8.4 Councillor meeting - 11th January 2019

8.5 Secured by Design

Richmond Design Review Panel

8.6 Planning objection comments

Revised ground floor plan showing commercial building on Edwin Road

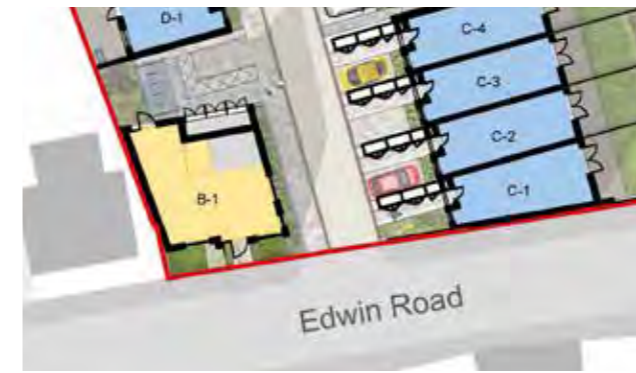
- The officer noted that residential use is a deviation from policy, however the team responded that industrial use is inappropriate for the site due to its residential location and the site constraints. As such, the officer confirmed that E commercial use could be considered.
- Encouragement for family houses notwithstanding policy considerations.

- The two houses fronting Edwin Road were removed and a new commercial building proposed in its place. This resulted in 116 residential units (47 houses and 69 apartments), and a E use Commercial unit that will appeal to SMEs.

Planning submitted proposal

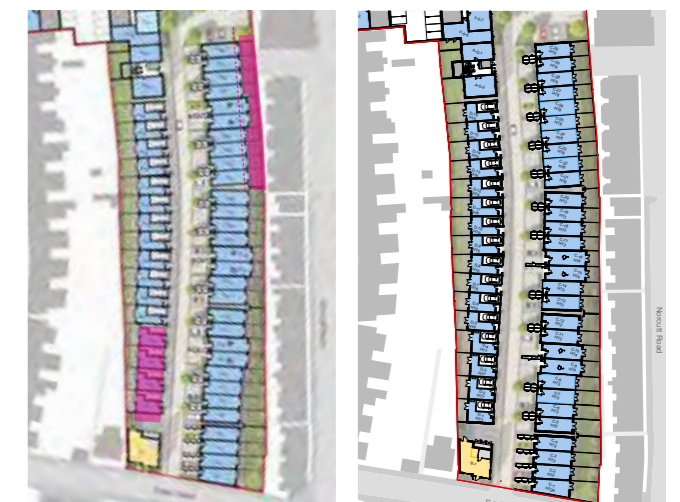
Lack of amenity space for houses (specifically C15-C30 and D1-D7). Adjust the typology and provide more generous space. Explore the inside outside relationship to make them more usable.

Increase in back garden depths is supported and are policy compliant however some still remain small.

All houses have been provided with a rear private garden which meets the London Plan and policy requirements, however garden sizes have been increased where possible. These measures include:

- House types C-15 to C30 shortened to increase garden sizes (houses remain London Plan compliant);
- Larger accessible houses with the smallest gardens relocated elsewhere and provided as apartments more suitable for wheelchair users;
- Patio doors to be provided with level threshold giving seamless access to the gardens, creating usable inside-outside space;
- House layouts D1-D4 amended to improve relationship with the garden.

Planning submitted scheme showing roof terrace

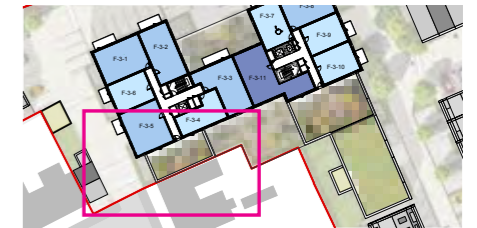
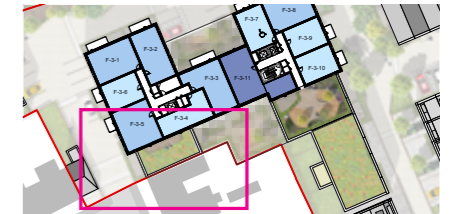
- Concerns over the massing at the junction of Gould Road and Crane Road in relation to existing terraces and overlooking from the roof gardens in Building F;
- Review the lantern roof and look at the option of a flat roof instead; not convinced of the darker tone.

- The roof of Building F appears over-heavy and appears to emphasise the upper-storey finish.

We have tested a variety of approaches in response to these comments. The flat roof option was tested but this gave a very blocky form that is largely alien to the area and did not compliment the existing roofscape. The following design amendments were subsequently made:

- Reduced parapet and roof terrace extent at junction of Gould Road and Crane Road, improving the relationship with the existing terrace of houses and reducing potential overlooking from the roof terrace;
- Amended treatment of fourth floor and roof profile to reduce visual impact from the street;
- Different material to reduce 'heavy' appearance;
- Retained lantern profile and roof pitch within a gable to best respond to existing buildings on site and local character.

Section showing visibility splay from balconies

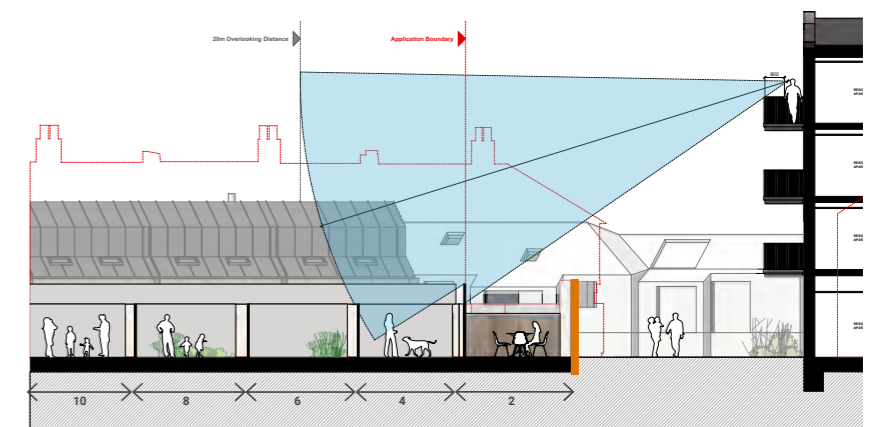
Fourth storey and balconies to the western end of Building F could have a negative impact and potential overlooking.

A full review of overlooking has been undertaken on these properties. The current proposal does not overlook existing windows, but does partially overlook the gardens of 4 Gould Road. Overlooking of gardens is a common condition within the area and within London and was considered acceptable by officers as part of the previous application. It is also important new apartments are provided with balconies where possible to meet London Plan.

However the design incorporates the following changes to reduce this perceived overlooking to benefit the existing owners of the gardens.

- Overlooking to neighbouring gardens minimised by garden of number 2 Gould Road and proposal to increase height of existing perimeter wall at site application boundary;
- Balcony railings amended to blades directing views towards the river providing residents with additional privacy and reducing overlooking from those sitting on the balcony or within the rooms.
